Access Compliance Report

Public Rights-of-Way

(Curb Ramps)

Intersection ID: 28397	Main Street: COMMONS_CROSSING_DR	Cross Street: WADE_ARDREY_RD	Location: NE
ADA ID: 84D89684BB58	Ramp Type: Perp	Initial Pass/Fail: Fail	Overall Compliance: No
Severity Score: 10			
Codes/Mitigation Info/Possible Solution		Field Measurements/Component Compliance

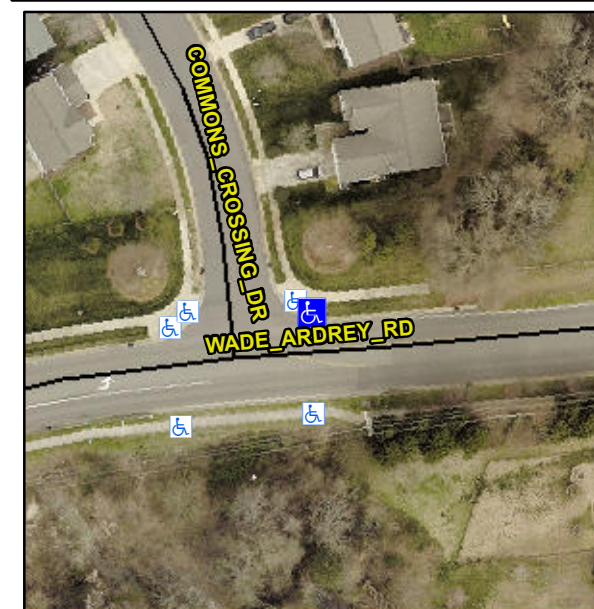
Not Found, R304.5.1, R304.5.3

Compliance	Description	Data	Compliance	Description	Data
N/A	Ramp Length (in)	96.0	Yes	Ramp Slope (%)	6.4
No	Ramp Width (in)	43.0	No	Ramp XSlope (%)	4.9
N/A	Flare Type LT	N/A	N/A	Flare Type RT	N/A
N/A	Flare Slope LT (%)	N/A	N/A	Flare Slope RT (%)	N/A
N/A	Flare Traversable LT?	N/A	N/A	Flare Traversable RT?	N/A
N/A	Landing Length (in)	N/A	N/A	DWS Provided?	N/A
N/A	Landing Width (in)	N/A	N/A	DWS Contrast?	N/A
N/A	Landing Slope (%)	N/A	N/A	DWS Length (in)	N/A
N/A	Landing X Slope (%)	N/A	N/A	DWS Full Width?	N/A
N/A	Landing Curb? (Y/N)	N/A	N/A	DWS Offset (in)	N/A
N/A	Shared Landing?	N/A			
N/A	Gutter Ponding?	N/A	N/A	Gutter Slope (%)	N/A
N/A	Gutter Lip Ht (in)	N/A	N/A	Gutter X Slope (%)	N/A
N/A	Painted X Walk1?	No	N/A	Painted X Walk2?	N/A
	X Walk 1 Direction	To S		X Walk 2 Direction	N/A
N/A	X Walk 1 Width (in)	N/A	N/A	X Walk 2 Width (in)	N/A
	X Walk 1 Slope (%)	4.4		X Walk 2 Slope (%)	N/A
	X Walk 1 X Slope (%)	1.7		X Walk 2 X Slope (%)	N/A

Remove & Replace Entire Ramp.
